SERVICE BULLETIN

BULLETIN NUMBER: SB-0041
REVISION: 1-0-0
DATE: AUG-2009

PRODUCT DESCRIPTION: CI-BC-4E Clear / Secure switching while in Local mode – CI-BC-4E base control module

PRODUCTS AFFECTED: CI-BC-4E-00 with switch (PCB 50139-02)

FIGURE 1

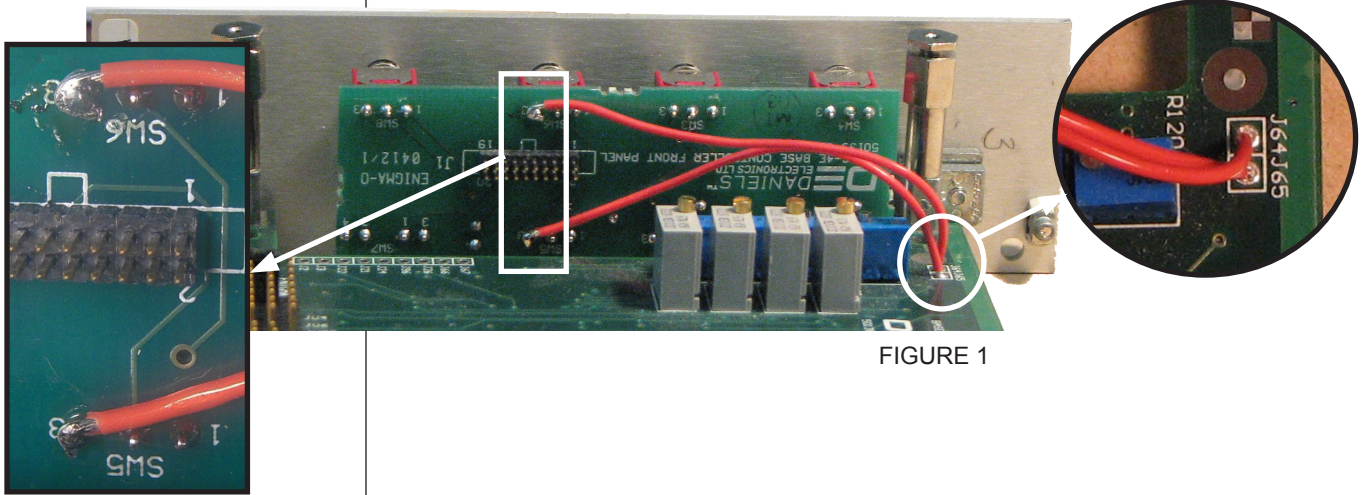
SYMPTOMS: MT-4E Transmitters with an encryption module installed will not switch to secure mode when Local control is enabled.

CAUSE: The clear / secure line is missing the required pull-up voltage.

SOLUTION: Add pull-up circuit to clear / secure lines to TXA / TXB.

PROCEDURE: Connect one wire jumper from front panel SW5 Pin 3 to J64 on main PCB top and another wire jumper from front panel SW6 Pin 3 to J65 on main PCB top (see Figure 1). Also replace R151 and R152 (see Figure 2).
